REQUEST

Current Zoning: B-1 (neighborhood business)
Proposed Zoning: MUDD-O (mixed use development, optional) with three-year vested rights

The petition proposes rezone a lot previously used as an auto car garage to allow the construction of a 9,000-square foot mixed-use building residential and nonresidential uses.

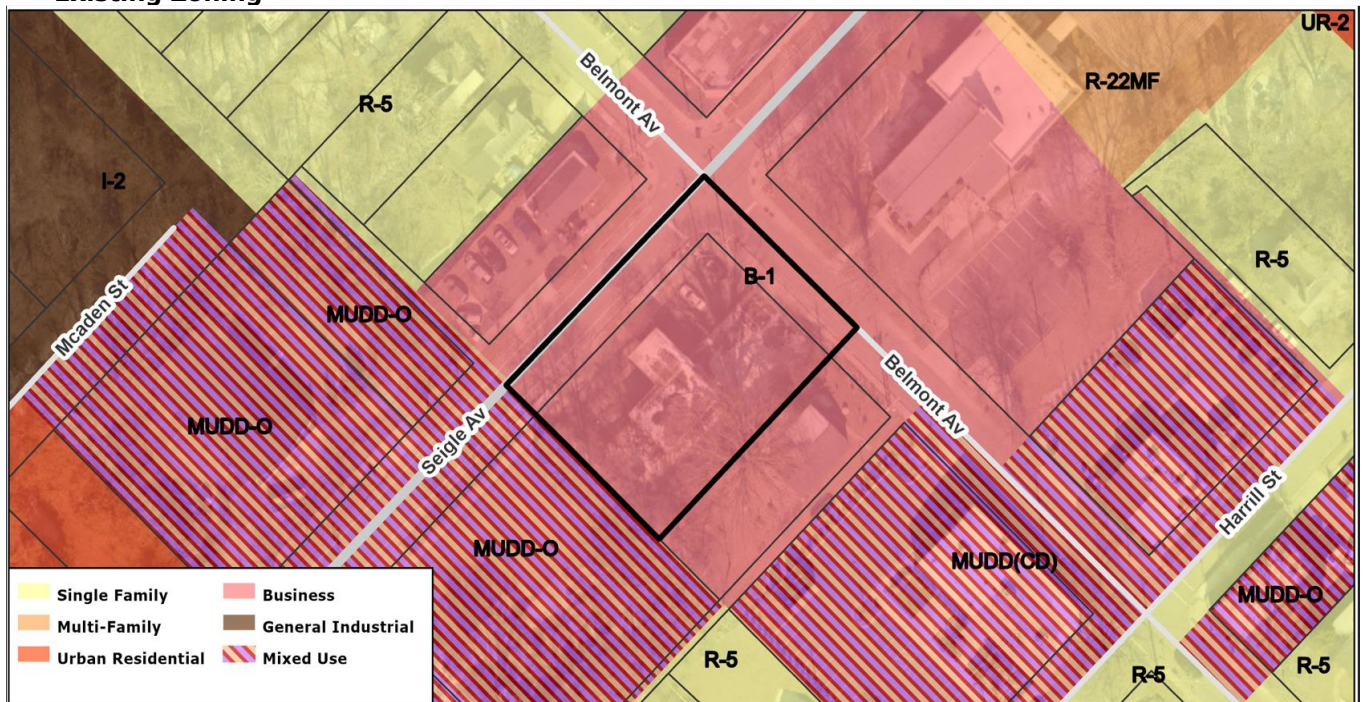
Existing curb and gutter can remain in existing location but label and dimension the future curb and gutter location from the centerline for each road on the site plan. Addressed

- ~~1. The site plan shall label and dimension the right of way from the road centerline. Site plan shows 25' to centerline but does not show the existing 50' from centerline. Label and dimension the existing 50' right of way from centerline of road.~~ Addressed

- ~~2. CDOT requests petitioner commit to 8' sidewalk and place Streets Map streetscape behind future curb location.~~ Addressed
- ~~3. Add a conditional note specifying "A Right of Way Encroachment Agreement is required for the installation of any non-standard item(s) (irrigation systems, decorative concrete pavement, brick pavers, etc.) within a proposed/existing City-maintained street right of way by a private individual, group, business, or homeowner's/business association. An encroachment agreement must be approved by CDOT prior to construction/installation. Contact CDOT for additional information concerning cost, submittal, and liability insurance coverage requirements."~~ Addressed

- ~~4. Add a conditional note specifying "the Petitioner shall dedicate and convey in fee simple all rights-of-way to the City before the site's first building certificate of occupancy is issued. CDOT requests rights-of-way set at 2' behind back of sidewalk where feasible."~~ Addressed

- ~~5. Petitioner should revise the site plan and conditional notes to show sidewalk utility easement on plans behind proposed sidewalk.~~ Addressed

6. ~~Petitioner should revise the site plan and conditional notes to show 10x10 triangles behind the sidewalk.~~ **Addressed**

7. ~~Review urban tree requirements. While the 10' no build zone can be counted towards tree save there must still be a minimum of 10' of replanted tree save. (20' total width) Trees cannot be planted within 10' of a structure/retaining wall. Utilities such as transformers are not permitted within trees save or amenitized tree save.~~ **Petitioner response:** Petitioner has reconfigured preliminary off-street parking layout to accommodate 10' distance & 10' width requirements. Potential transformer locations have been moved outside of amenitized tree save (See Site Plan on RZP-01, Rev 2). **Update:** Per discussion, the best option for tree save at this point will be provided per the ordinance and removed "potential tree save" designation for areas that we not sure would even qualify as tree save and review that during development plan review. **Addressed**

8. ~~Trees outside of the property line cannot count towards any requirements. Trees must be completely on the property to count towards requirements.~~ **Petitioner Response:** Petitioner commits to protecting the five "property line trees" on southern property line. (See Note 2D, RZP-01 Site Plan, Rev 2). Petitioner is open to amending the wording of this Optional Provision to suit Urban Forestry, if desired. Note: as provided to Henry Kunzig via 4-17-23 email, center measurement of 12" oak is completely on property at dbh. Updated Tree Survey uploaded to ACCELA. Petitioner is willing to reduce protection to just that tree, if desired. **Update:** While trees on the property line can be protected, trees not completely located on the property cannot be counted towards meeting tree save requirements. **Addressed**

9. ~~Please confirm if residential is proposed as it is not specified under proposed uses.~~ **Addressed**
10. ~~Under proposed list of permitted uses, please modify Type EDEE Types 1 and 2 to note subject to ordinance requirements.~~ **Addressed**
11. ~~Under proposed list of permitted uses, please modify breweries to note subject to ordinance requirements.~~ **Addressed**
12. ~~Include minimum % brick required on ground floor.~~ **Addressed**
13. ~~Include minimum area for public open space required.~~ **Addressed**
14. ~~The precedent imagery is showing a structure constructed with brick. Recommend brick being used as a primary building material on the first floor.~~ **Addressed**
